WAY-585-2.73 KCK Construction Markups

CITY OF WOOSTER
WAYNE TOWNSHIP
WAYNE COUNTY

THIS PROJECT CONSISTS OF UPGRADING THE INTERSECTION OF SR 585 (AKRON ROAD) AND TR 68 (NORTH GEYERS CHAPEL ROAD) TO A MODERN ROUNDABOUT. THIS PROJECT INCLUDES LIGHTING, DRAINAGE, SIGNING, AND STRIPING WORK. THE TOTAL PROJECT WORK LENGTH IS 0.36 MILES.

TRAFFIC CONTROL PLAN - ROUNDABOUT

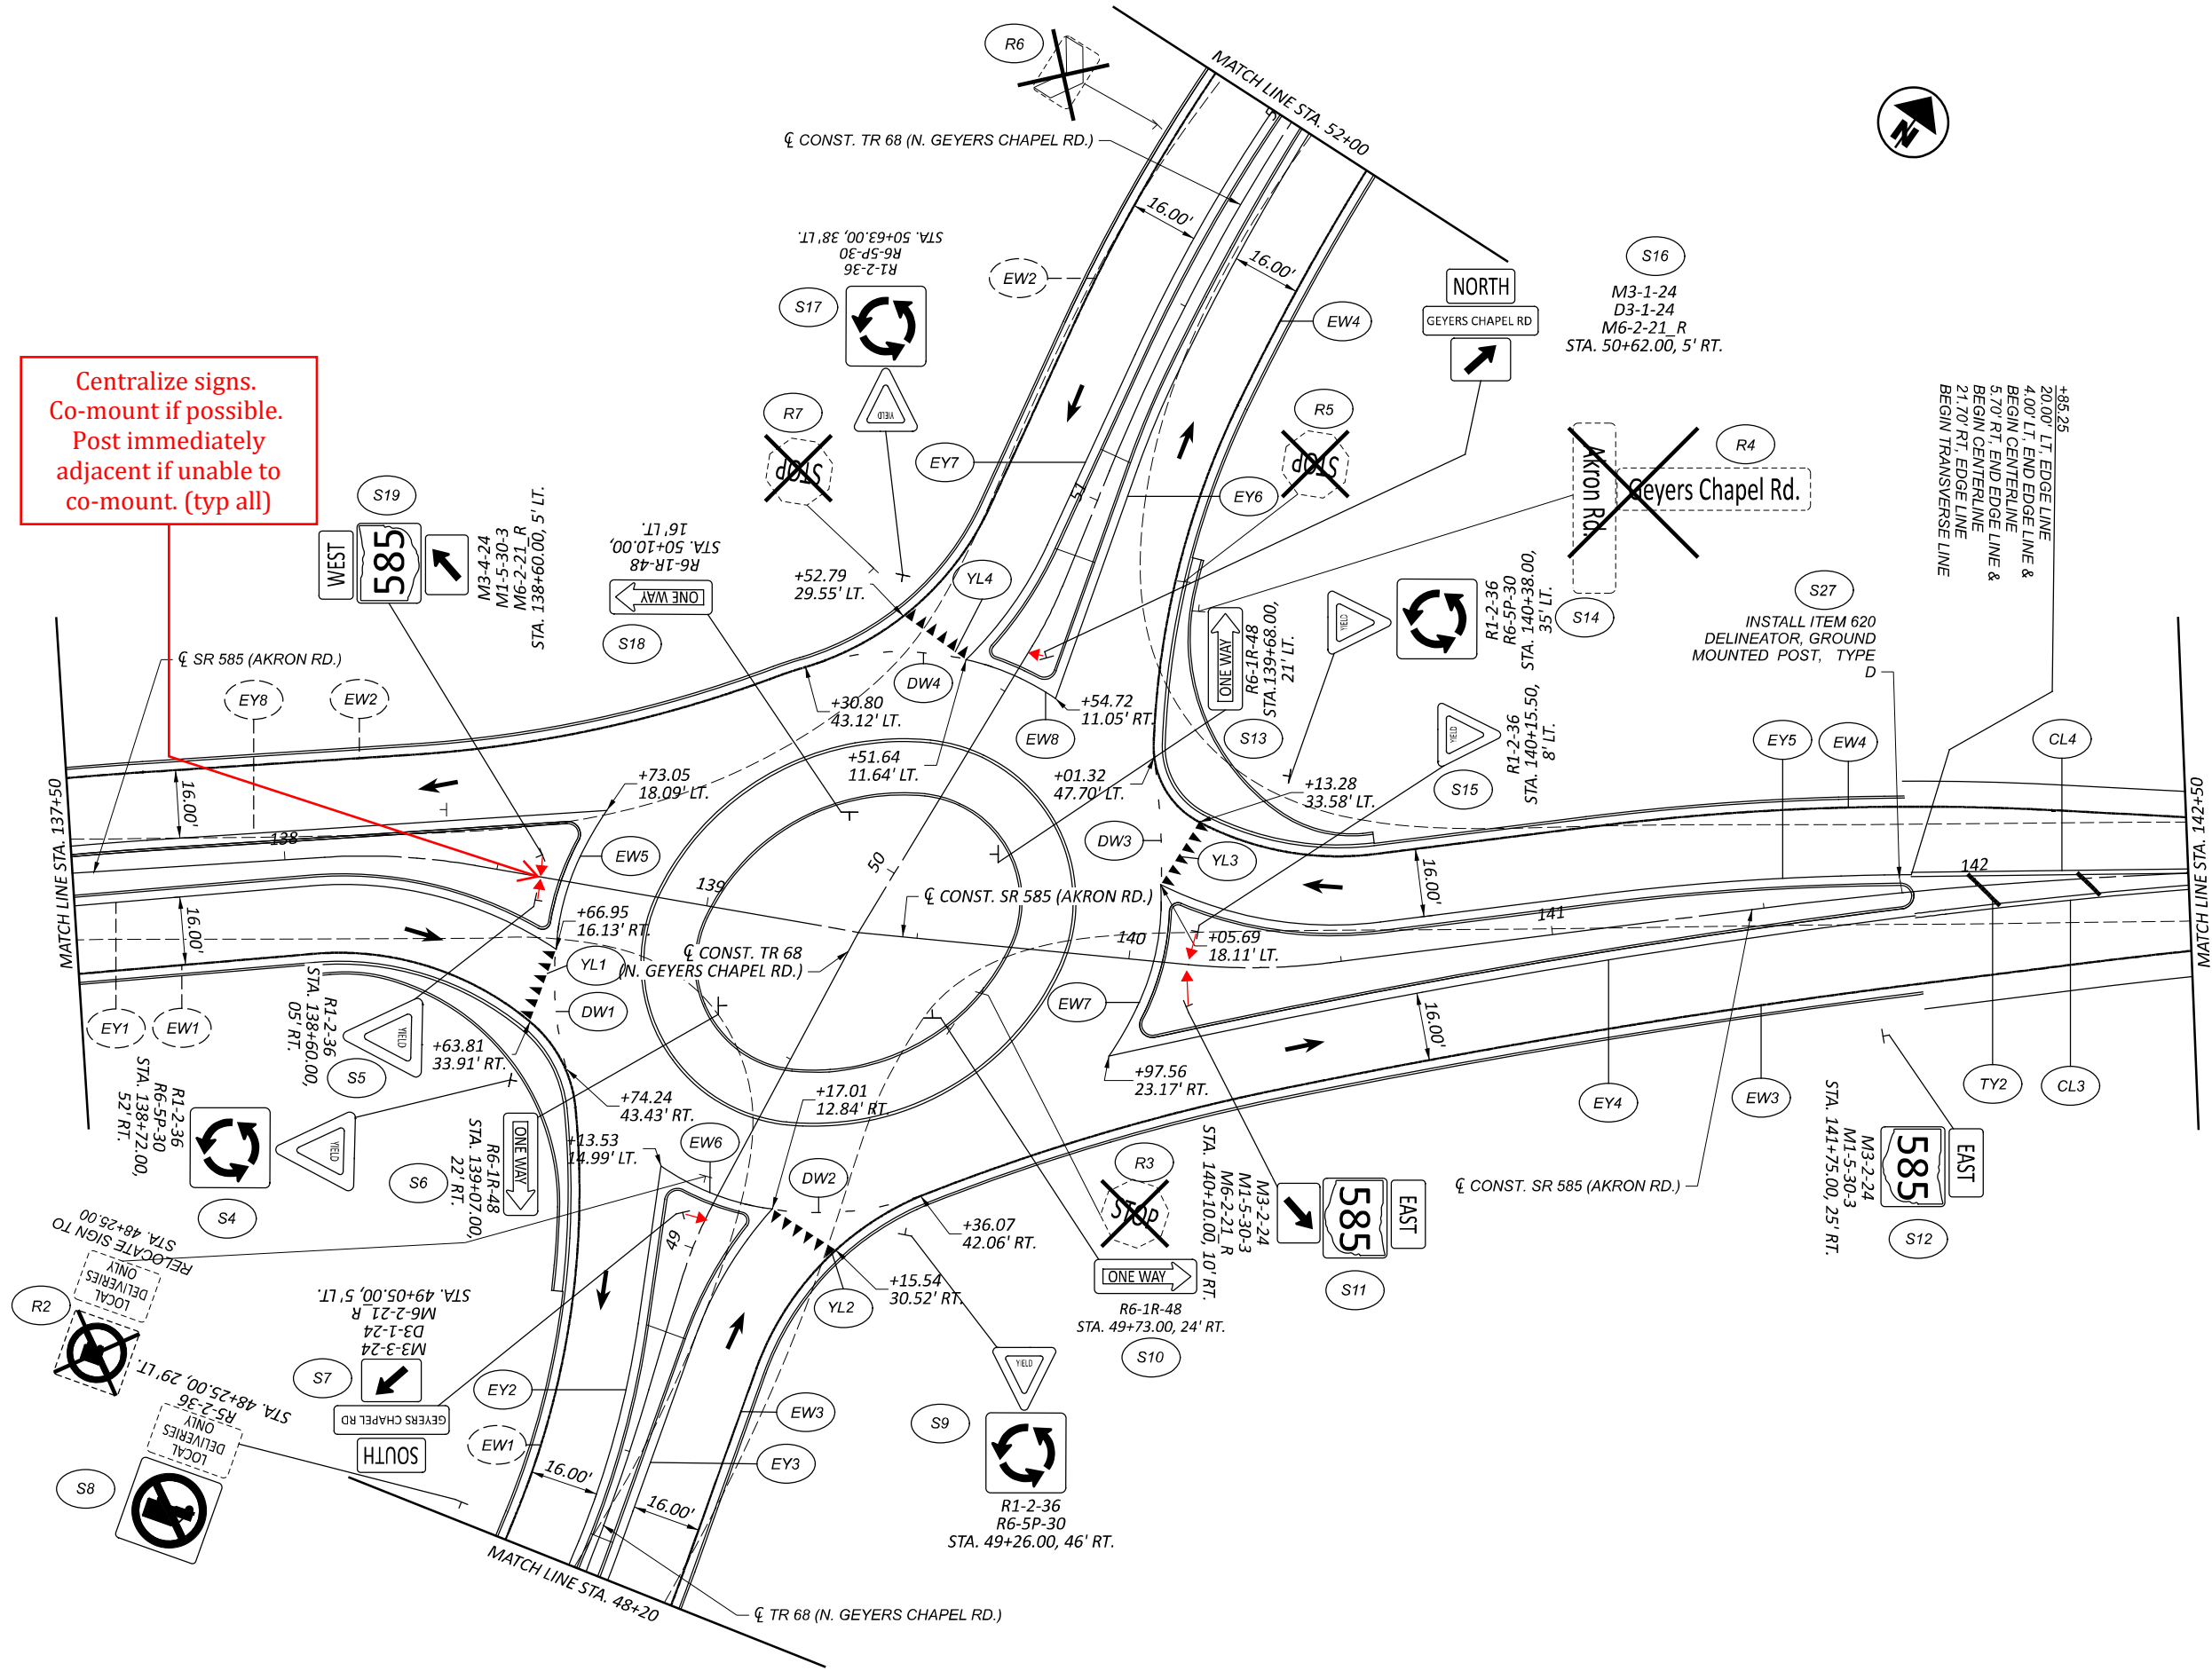
Centralize signs.
Co-mount if possible.
Post immediately
adjacent if unable to
co-mount. (typ all)
